# UNITED STATES PATENT AND TRADEMARK OFFICE

APPLICATION NO.	FILING DATE	FIRST NAMED INVENTOR	ATTORNEY DOCKET NO.	CONFIRMATION NO.
10/582,428	08/02/2007	Kenneth W. Kwochka	TEVA-109US	4844
23122	7590	01/06/2009	EXAMINER	
RATNERPRESTIA			TREYGER, ILYA Y	
P.O. BOX 980			ART UNIT	PAPER NUMBER
VALLEY FORGE, PA 19482			3761	
			MAIL DATE	DELIVERY MODE
			01/06/2009	PAPER

### Office Action Summary

**DETAILED ACTION**

**FIG 3**

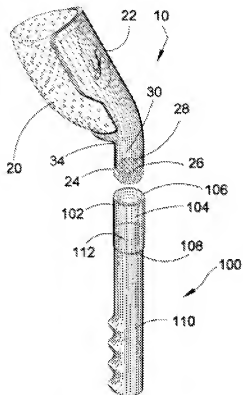
4. In Re claims 1 and 7, Yannaci discloses a liquid applicator including a reservoir 104 (Col. 6, line 5; Figs. 3 and 11) having an opening 106 (Col. 6, lines 7; Fig. 3) for dispensing the liquid contained in the reservoir and the device 10 (Col. 5, line 47; Fig. 3) comprising:

the applicator housing 22 (Col. 5, lines 59, 64; Figs. 3 and 11) that is the plate having a matrix of apertures 32 (Col. 5, line 65; Fig. 11) (claim 7);

a threaded end 24 (Col. 5, lines 55, 56; Fig. 3) that is a connector for connecting to the opening 106 (Fig. 3) in fluid communication with the opening 106 (Fig. 3) of the reservoir 104 (Fig. 3); and

the applicator head 22 (Fig. 3), which is a medicament applicator (Col. 6, lines 64-67) made from a fluid permeable material attached to the plate 22 (Figs. 3 and 11) and fully capable of being detached.

**FIG 7**

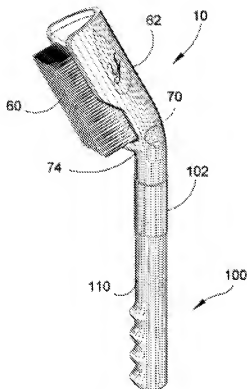
the applicator brush head 60 (Fig. 7) having a bristles (Col. 7, lines 44, 45).

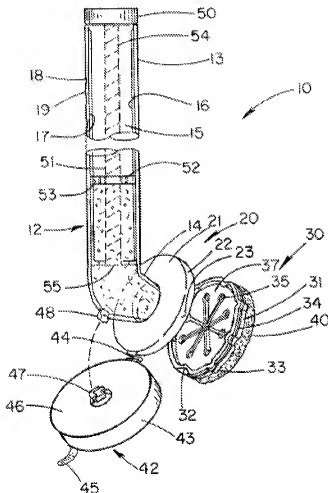
Pipkin teaches the liquid applicator, wherein the plurality of flexible hooks have been used for the fixation of elements (Col. 3, lines 35, 36), and wherein the plurality of hooks is interpreted as a plurality of protrusions, and the plurality of loops is interpreted as a plurality of holes (claim 6).
